Section 6.1 Mechanical Requirements

Draft IPRD Requirement RBPRD-0067:

Figure 6.1-1 Instrument Dimensional Envelope

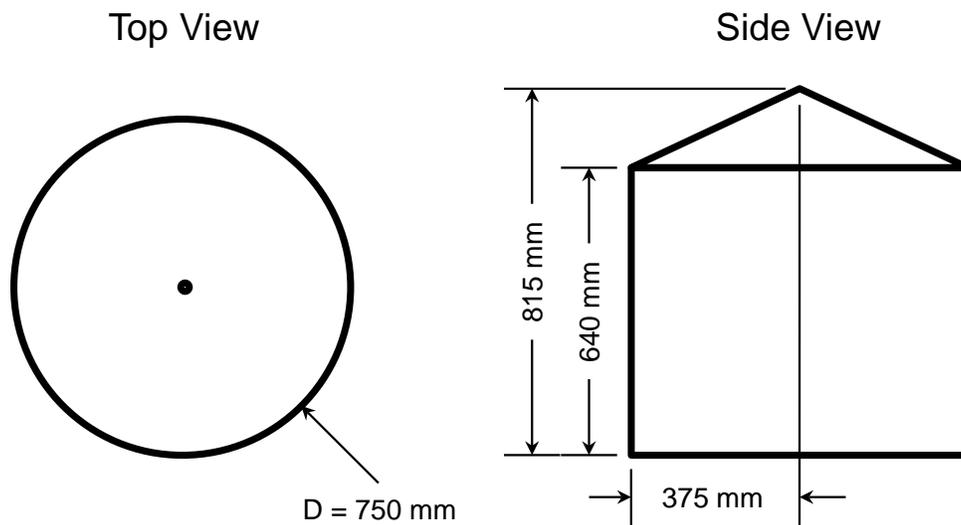
FROM:

The Instrument dimensional envelope, including deployable mechanisms, shall not exceed 0.95 m × 0.95 m × 0.95 m.

TO:

The Instrument dimensional envelope, including deployable mechanisms, shall not exceed the volume shown in Figure 6.1-1.
